Appendix H

Traffic assessment issues analysis and response

To: Thomas Frankham
From: Ody Murlianto
Subject: **Hunter Valley Operations Continuation Project EIS Review**
Our ref: PS204979-SYD-PAM-MEM-002
Date: **13 October 2023**

Figure 2.7 Traffic volume estimates under existing conditions and with Lemington Road realignment

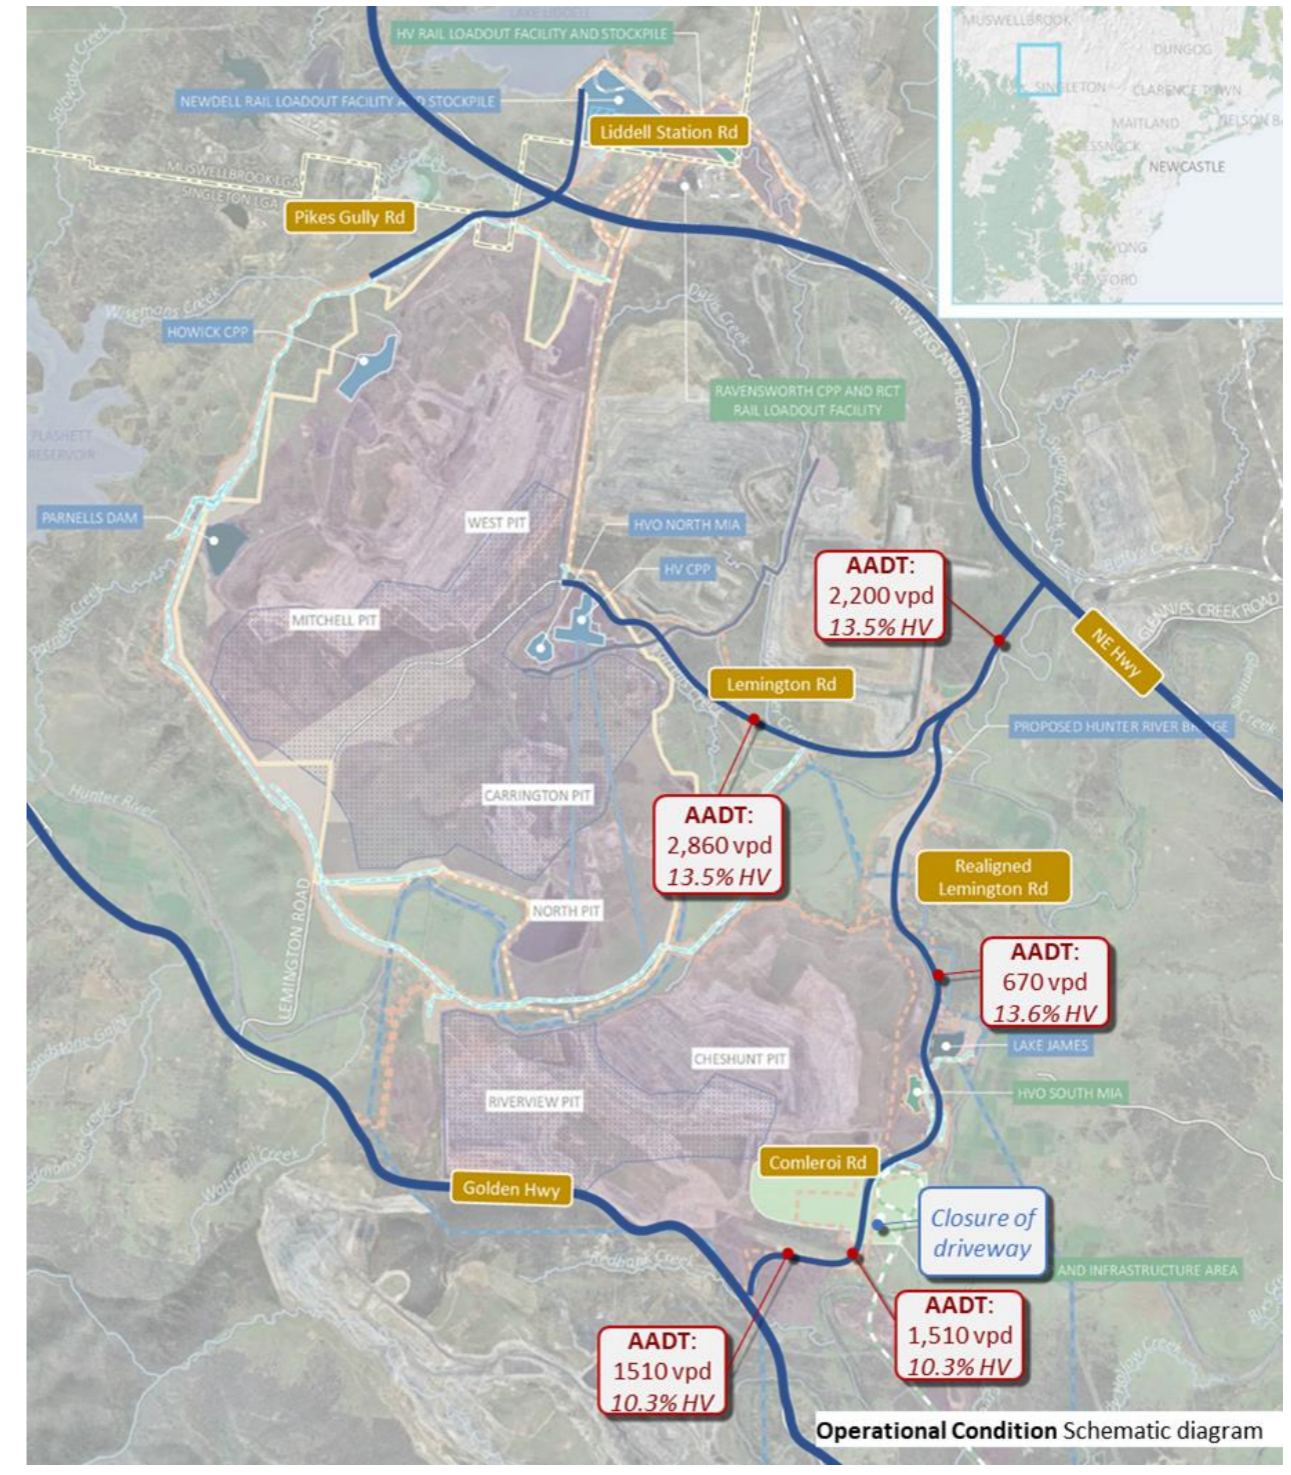
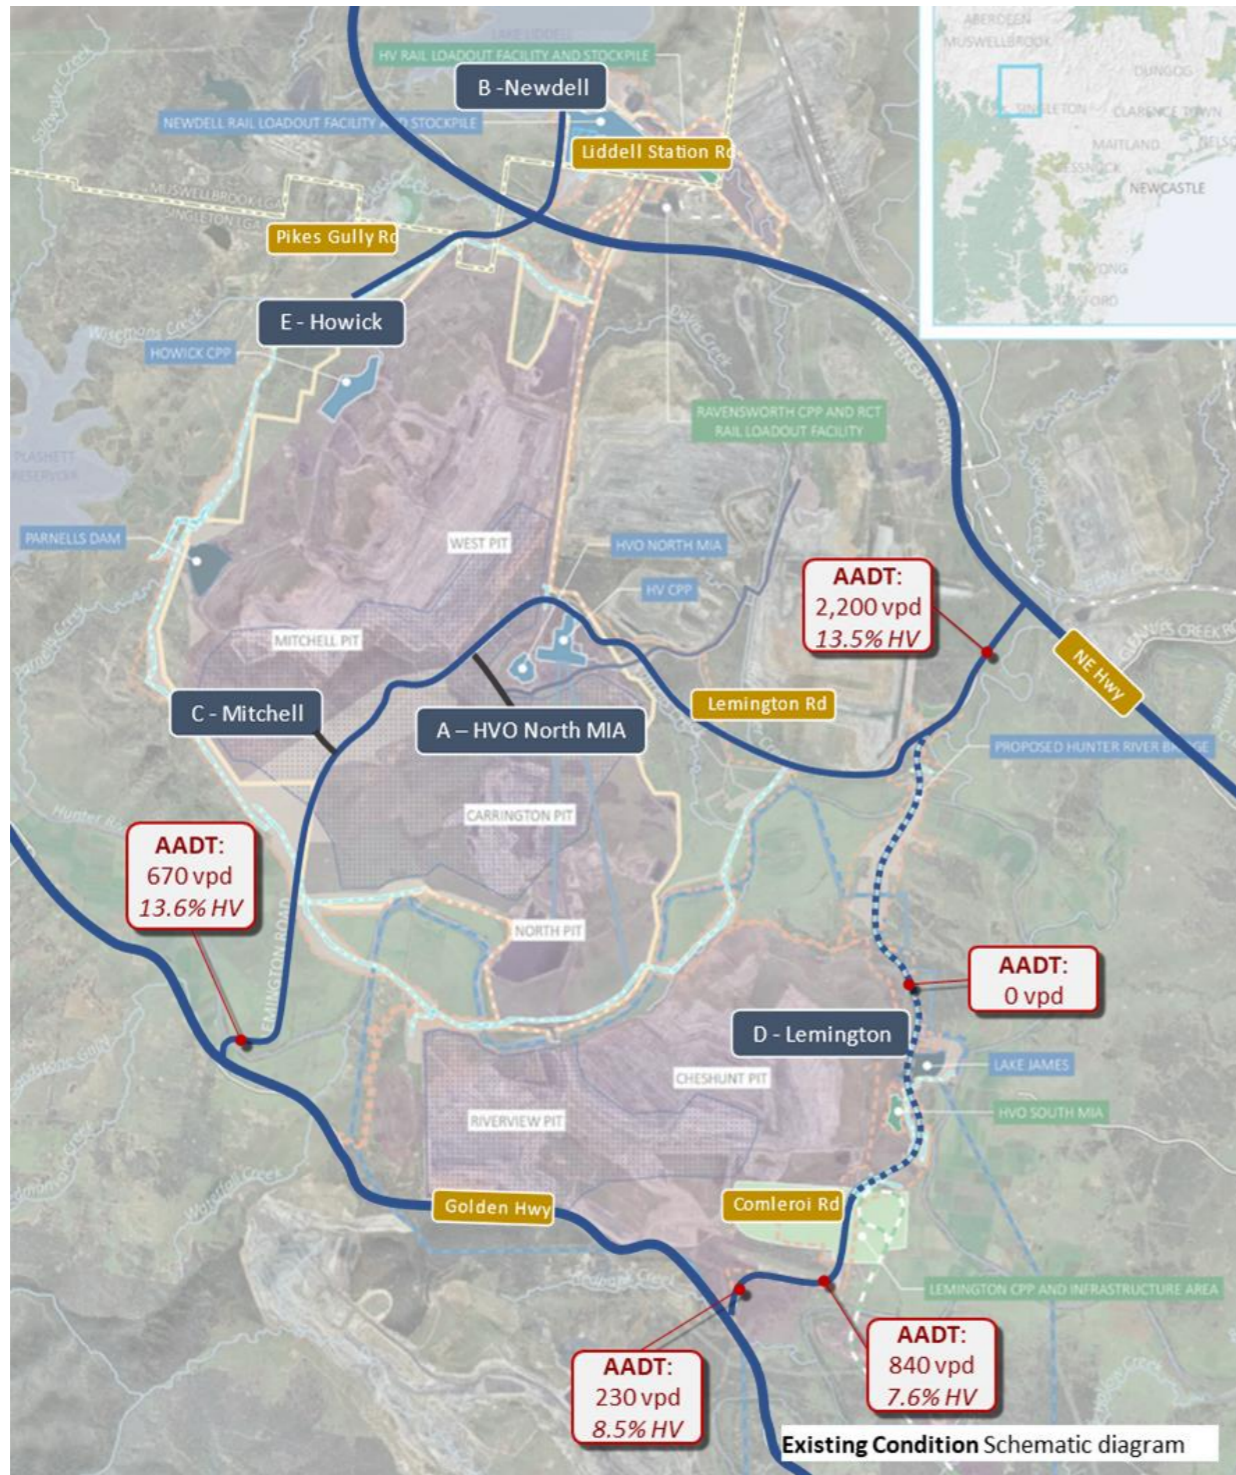
While the increase is not shown explicitly in the traffic data in the EIS, the realignment will materially and significantly increase traffic on Comleroi Road, perhaps in the order of 50%. During peak traffic flows such as shift change in adjacent mines, queues of traffic will be expected to form from the intersection with the Golden Highway.

Figure 2.7 provides a summary of the traffic volumes on Comleroi Road and Lemington Road under existing conditions and with the realignment of Lemington Road, and closure of the private driveway access north of the HVGC. This driveway links between Comleroi Road (east of HVGC site) to the Golden Highway (west of Long Point Road West). This driveway provides access to a large proportion of HVO South and reduces the number of trips using Comleroi Road outside of the HVGC access point.

The impact of the Lemington Road realignment would mean that current trips on Lemington Road into/out of the Golden Highway would be detoured using Comleroi Road. This would mean the AADT of Comleroi Road outside of the HVGC may increase from 230 vehicles per day (as surveyed in September 2020) to potentially 900 vehicles per day. Additionally, with the closure of the private driveway access, the AADT of Comleroi Road outside of the HVGC may increase to 1510 vehicles per day.

Based on detailed analysis at the Golden Highway/Comleroi Road depicted in Table 2.1 above, the Lemington Road realignment and HVO private driveway access closure accounts for 145 vehicles per hour at the worst, in the AM peak. This is equivalent to approximately 12 vehicles every 5 minutes, which is still considered very low demand and not likely to result in adverse operational impact.

Figure 2.10 HGVC Driveway treatment schematic design

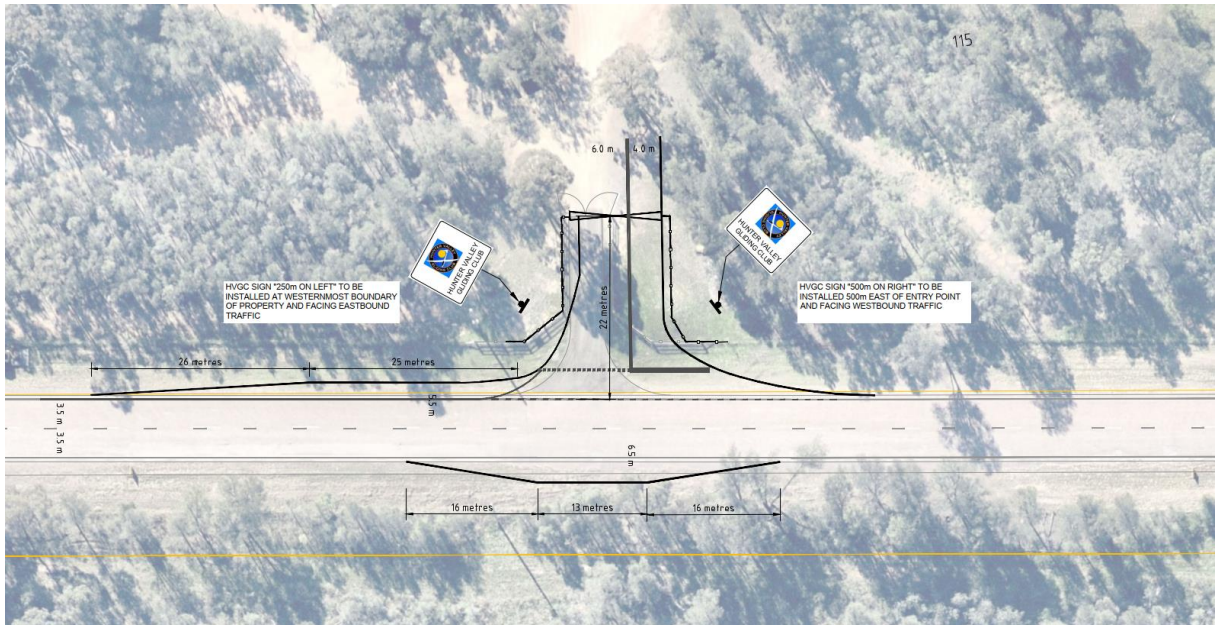
The driveway to the HVGC facilities and Warkworth Airfield is relatively narrow and visually unobtrusive. It requires vehicles to all but stop in the travel lane before turning. This is especially so for club members' vehicles towing glider trailers which are typically nine metres in length.

Appropriate traffic management measures will be required to avoid creating a hazard as other drivers have limited visual cues that there is an exit and vehicles may be slowing and stopping.

To address HVGC’s concerns for safety and access at their access driveway, a number of modifications have been considered to improve access and visibility of the access driveway at its approaches. These include:

- Widening the existing HVGC driveway to allow two-way traffic. Given the limited daily operation of HVGC, it is assumed that the club generates approximately 6 movements (combined inbound and outbound) daily at its peak. Additionally, HVGC has indicated an anecdotal observation of six movements per month of vehicles consisting of a car and trailer combination. While this demand is low, this treatment would further minimise potential queuing on Comleroi Road resulting from sharing the same driveway for inbound and outbound traffic movements.

The access gate location is to be approximately 22 metres away from the shoulder line marking to ensure that the entire length of a car towing a glider trailer can be accommodated away from the road carriageway to ensure safety. HVGC club member are able to pull in entirely off Comleroi Road to lock/unlock the gates as necessary.

- Increase the footprint of the intersection to accommodate concurrent inbound and outbound traffic movements. This is particularly important for the left turn inbound and right turn outbound movements, given that most trips into/out of the HVGC via the Golden Highway are serviced by these movements.
- Provide “Hunter Valley Gliding Club” signage at the access gate to face eastbound and westbound, and at the approaches to the access gate at an appropriate distance to inform road users of the location of the access gate.

A driveway is to be considered as an intersection if it fulfils the criteria for Category 5 driveway. An intersection design option (e.g. a BAL/BAR treatment) would have added safety benefits to allow through traffic on Comleroi Road to overtake turning vehicles into the HVGC. However not necessary, given the low demand the HVGC generates (6 movements per day) and low traffic volume on Comleroi Road (approximately 1,500 daily traffic, or an estimated 145 vehicles/hour in peak period) with HVO Continuation project.

The schematic design is shown in Figure 2.10. The scaled drawings and turning path assessments are attached in Appendix B. These design are subject to the appropriate detailed design and approvals.

The turning path assessment has considered the concurrent inbound and outbound movements from either direction of Comleroi Road to the driveway of the Glider Club. These includes vehicles towing a glider trailer as per Transport for NSW vehicle specification and 14.5 metres long rigid bus to consider the movements for coaches.

Figure 2.11 Lemington Road revised road alignment to avoid WSW

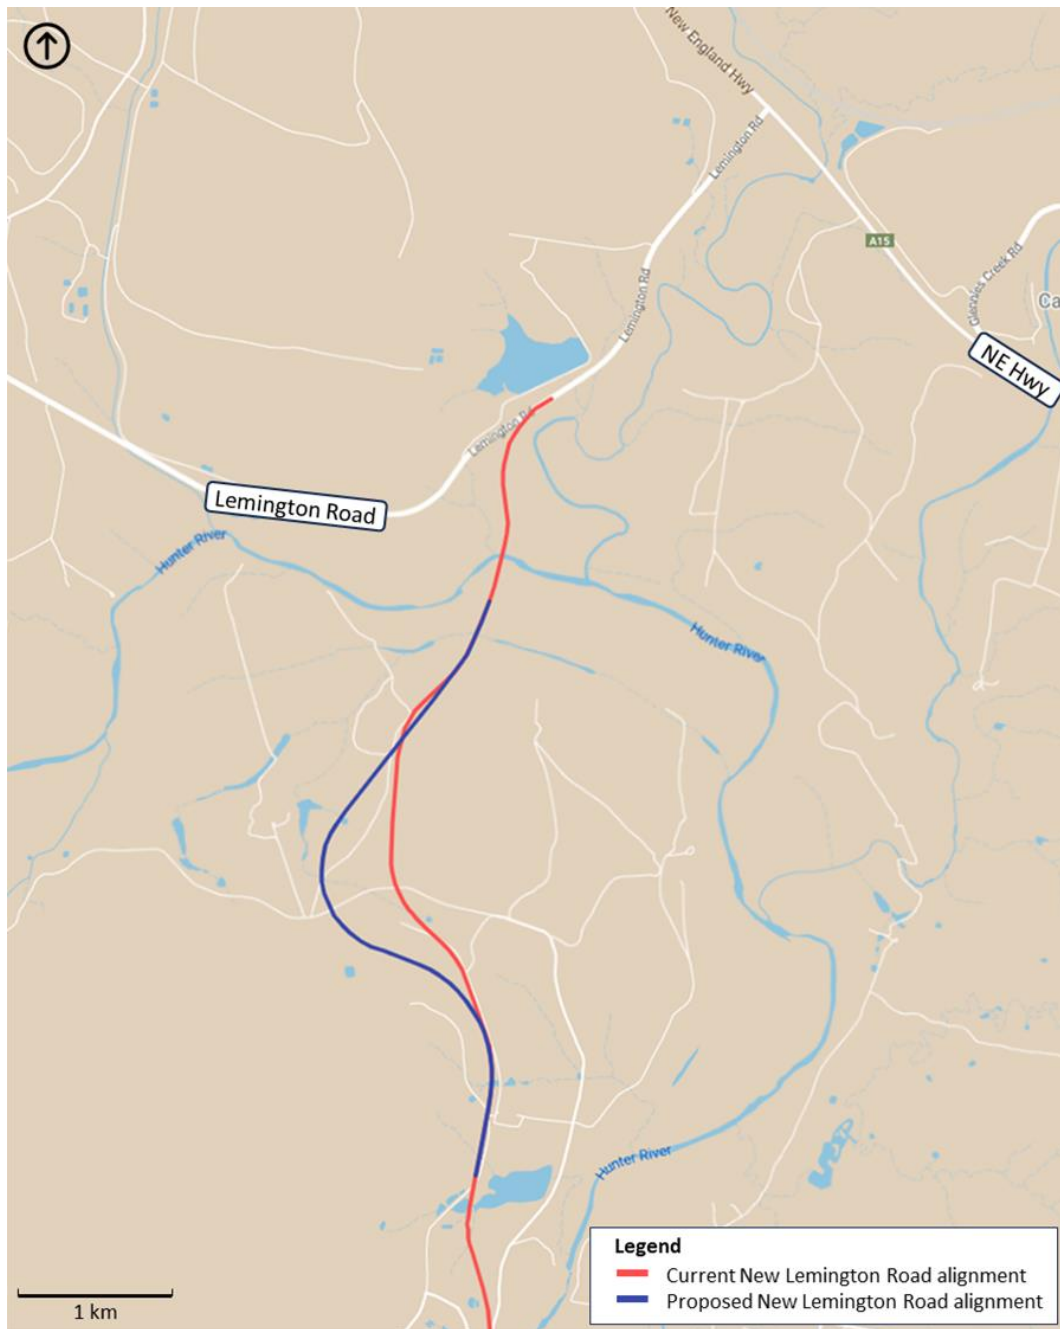
Since lodgement, an opportunity has been identified to modify the proposed Lemington Road alignment to minimise impact to Warkworth Sands Woodland (WSW). To facilitate this Project change, an Amendment Report is required to be submitted to DPE to modify DA SSD 11826681 for HVO North.

The revised (shown in blue line) and previously proposed (shown in red line) alignments are shown in Figure 2.11. WSW avoided by the revised alignment is further discussed within the revised Biodiversity Development Assessment Report (Umwelt 2023) appended to the HVO North Amendment Report (EMM 2023).

The new features of the new alignment are described as follows and are subject to further detailed design:

- The new alignment adds about 580m to the relocation.
- Designed to Austroads for 110km/hr (and sign posted to 100km/hr) criteria, consistent with the existing condition and current design of Lemington Road realignment.
- Maintains cross section design in the current design of the Lemington Road realignment.
- Does not impact proposed improvements to creek crossings along Lemington Road (i.e. across Hunter River) proposed in the current alignment. Creek crossing across the Hunter River is currently only serviced by the Moses Crossing, which can be inundated during heavy rainfall events.
- There are two low traffic property accesses proposed, one to service a property along existing Archerfield Road (to the west), the other is an access point to the TransGrid transmission line (to the east).
